# OPTIONAL SERVICE BULLETIN

## OSB 42-145

Installation of SBAS Equipment and activation of SBAS.

## WI-OSB 42-145

| IF NOT OTHERWISE SPECIFIED GEOMETRIC DIMENSIONING AND TOLERANCING ACC. TO<br><b>ISO 2768-mK</b> | DRAWN: C. Dvorak<br>20 MAY 2022   | TITLE<br><b>GPS Antenna GA35 Installation</b> | DWG.NO.<br><b>D60-3453-40-00x01</b>   |   |

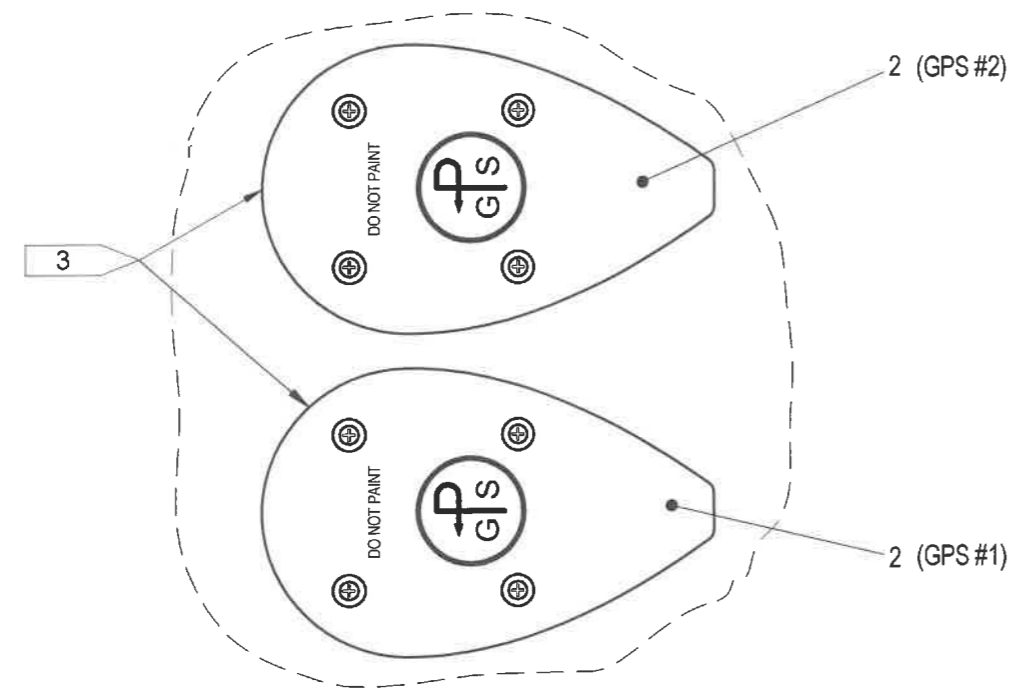
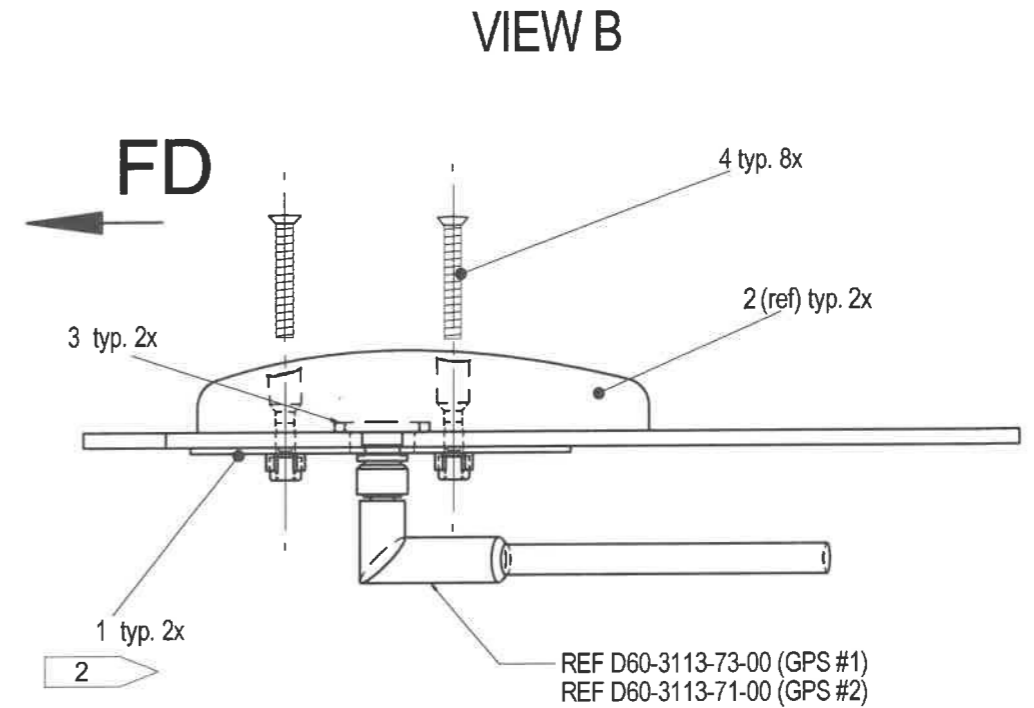
| 3  | Replace the installed GPS antennas with the new GPS antennas (GA 35) as listed in Section II.3 according AMM, Chapter 34-50 and drawing D60-3453-40-00x01.   |
| 4  | Replace the co-axial connectors of the GPS antenna cables with new TNC connectors, P/N 5225554-6 using appropriate tools. Connect the cables to the antennas.  |

- FLAG NOTES**
- 1 ITEM 3 IS PART OF ITEM 2.
  - 2 ENSURE ITEMS 1 ARE CONNECTED TO THE LIGHTNING PROTECTION SYSTEM.
  - 3 APPLY APPROVED SEALANT AROUND ANTENNA EDGE AND AIRCRAFT SKIN AFTER INSTALLATION
